TASCAM

SUPPLEMENT

DA-30MKII/DA-25

CYL HEAD ASS'Y REPLACEMENT

Fig. 1

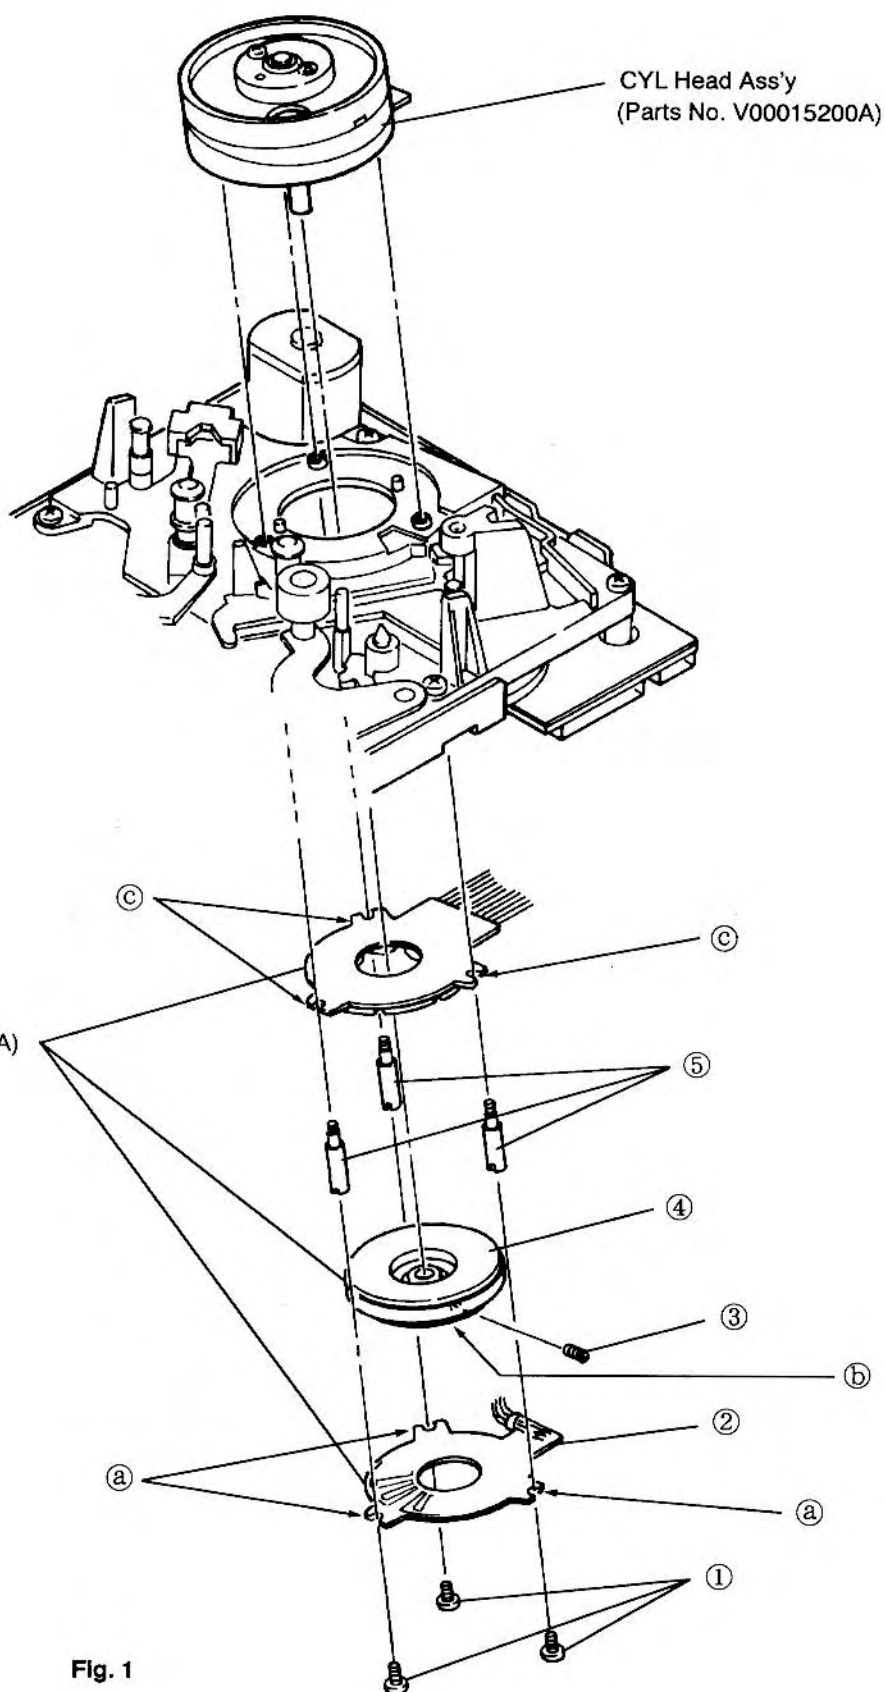
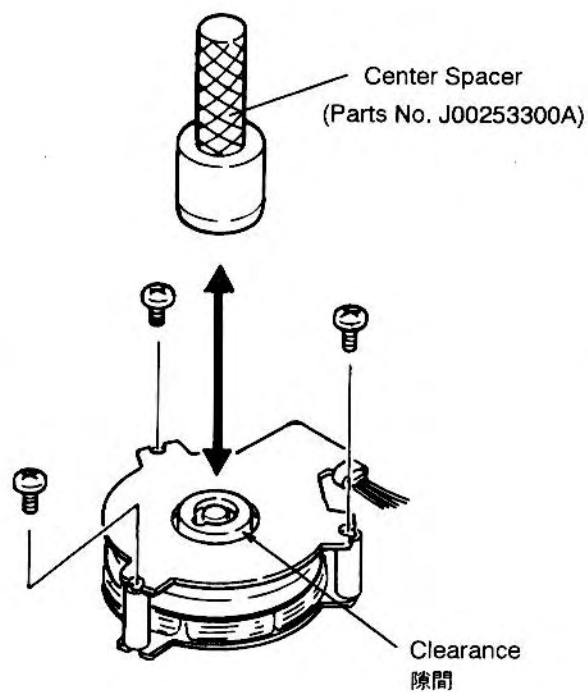
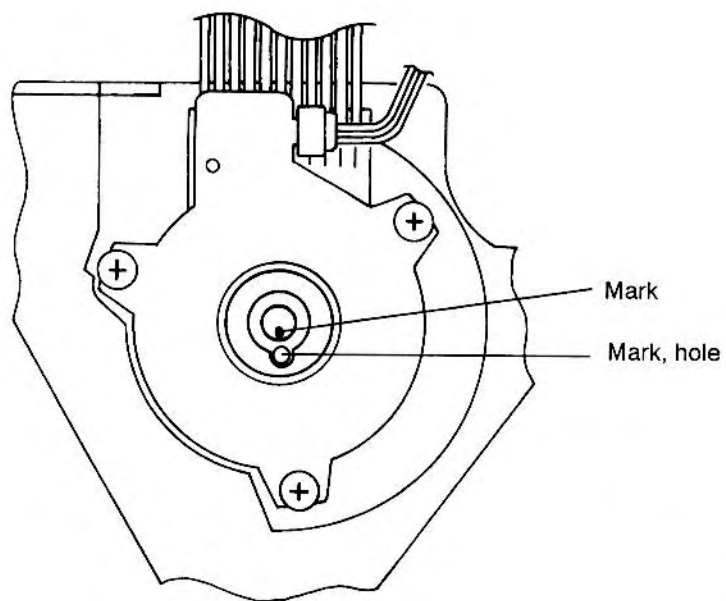
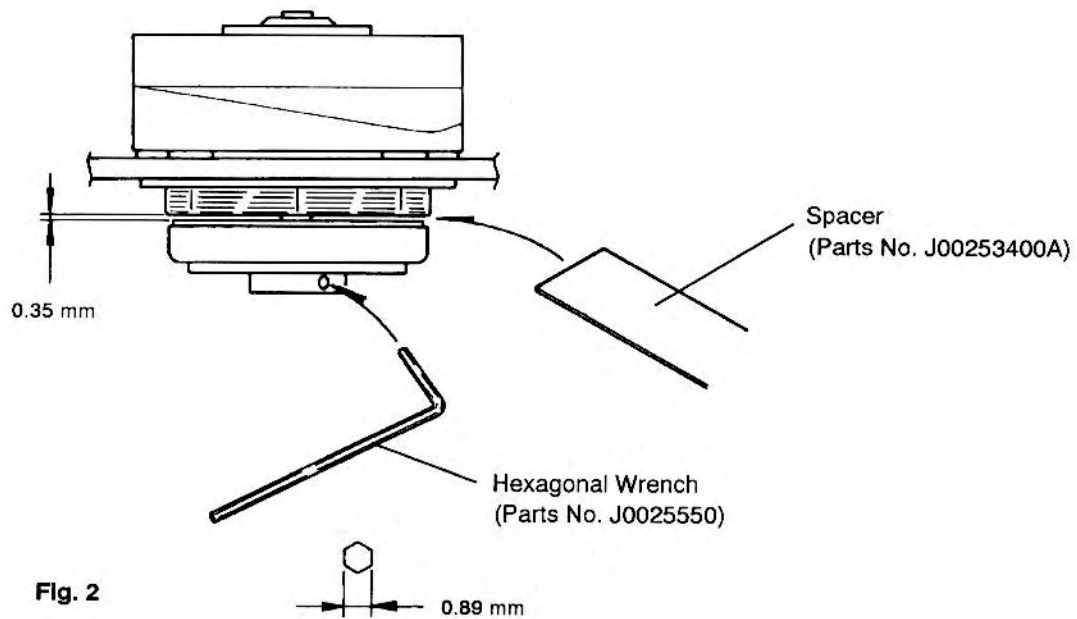
A PG alignment mark has newly been provided on the shaft of the CYL Head Ass'y. It allows the CYL Head Ass'y only to be replaced (not together with its base as before).

1. Remove the Cassette Holder Block and the RF Amp Block from the mechanism assembly (refer to page 5 of the provided service manual).
2. Remove three screws ① (part no. 5761809600), and remove part ②.
3. Dissolve the screw-locking compound at ⑤ with an appropriate solvent, then loosen screw ③ (part no. V00015500A) with a hexagonal wrench (Fig. 2) and remove part ④.

- * Do NOT touch the surface of the CYL Head Ass'y with naked hands. (It is recommended that you draw on gloves.)
- * When mounting part ④, use a 0.35 mm thick spacer to allow the necessary clearance as shown in Fig. 2. Align also the mark on the shaft with the positioning hole in part ④ as shown in Fig. 3. Alignment when the mark on the shaft goes indistinct in the future is explained on page 5 of this supplement.

- * When mounting part ②, insert a center spacer for the clearance shown in Fig. 4 to be even.
- * Tightening torque for screws ① and posts ⑤ should be 0.3 kg·cm. You need the following tools:

- * When removing the hexagonal wrench after fully tightening screw ③, be careful NOT to loosen the screw.
- * If the TACH adjustment (discussed on page 21 of the provided service manual) after completion of installation does not allow you to get the adjustment value of $803.6 \pm 15 \mu s$, then reassemble part ④ by slightly sliding the mark on the shaft counterclockwise with respect to the positioning hole in part ④. (See also page 6 for technical information.)

Fig. 5

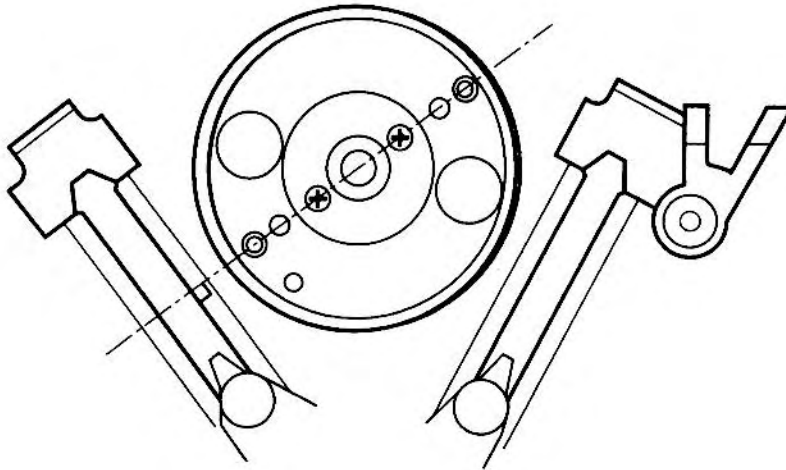
Using the diagrams below as a guide, match part ④ and the shaft. The Figure 5 shows the alignment when viewing the mechanism assembly from above and the Figure 6 shows the alignment viewed from below.

Fig. 7

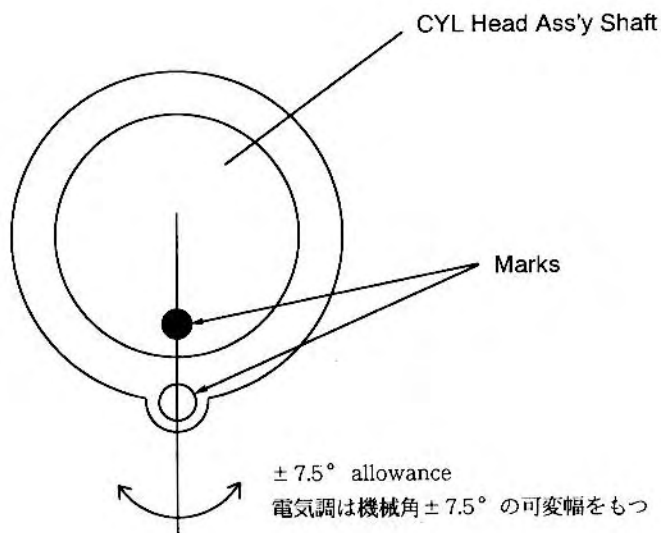
After the CYL Head Ass'y is replaced, the TACH width must be readjusted. The CYL Head Ass'y is installed by aligning the mark on it with the mark on the CYL Motor Kit. The relationship between this mechanical alignment and the electrical TACH adjustment is discussed below :

The DA-30MKⅡ/DA-25 provides the TACH adjustment range of about 1.3 ms. One rotation of the drum is achieved in 30 ms and the electronically adjustable TACH range is expressed as $1.3/30 = \text{about } 4.3\%$. So you can get this equation : $360^\circ \times 0.043 = 15.5^\circ$. Which means that the positioning marks each have the allowance of about $\pm 7.5^\circ$ as shown in Fig. 7.

7.5° is a subtle quantity. Great care is needed to achieve a good mechanically aligned installation of the CYL Head Ass'y.
